Unbalanced output connection diagrams

Figures affected: Figure 24, 402/802 II Controller Service Manual, P/N 174785. Figure 19, 502 (Panaray) Service Manual, P/N 170310.

Figure 1. Corrected Unbalanced Output Connection Diagrams

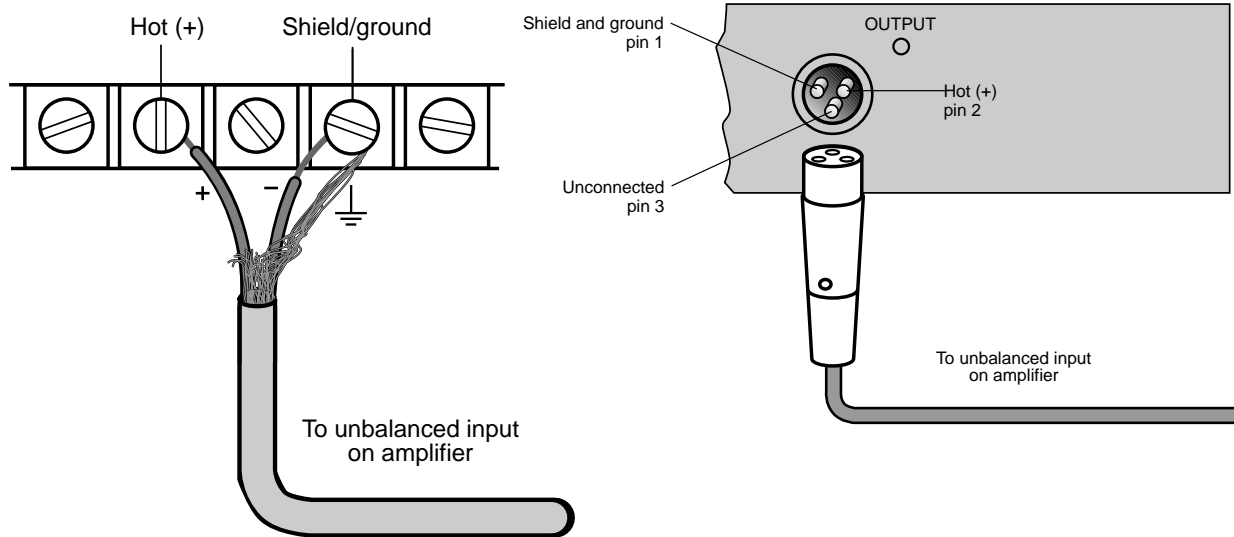
The unbalanced output connection diagrams shown in these manuals are incorrect.

For barrier strip connectors: The shield and ground wires **MUST** connect to the **ground** terminal for the output connections, not the **negative** terminal. See **Figure 1** for reference.

For XLR connectors: The shield and ground wires **MUST** connect to **pin 1** for the output connections, not **pin 3**. **Pin 3** is unconnected, not **Pin 1**. See **Figure 1** for reference.
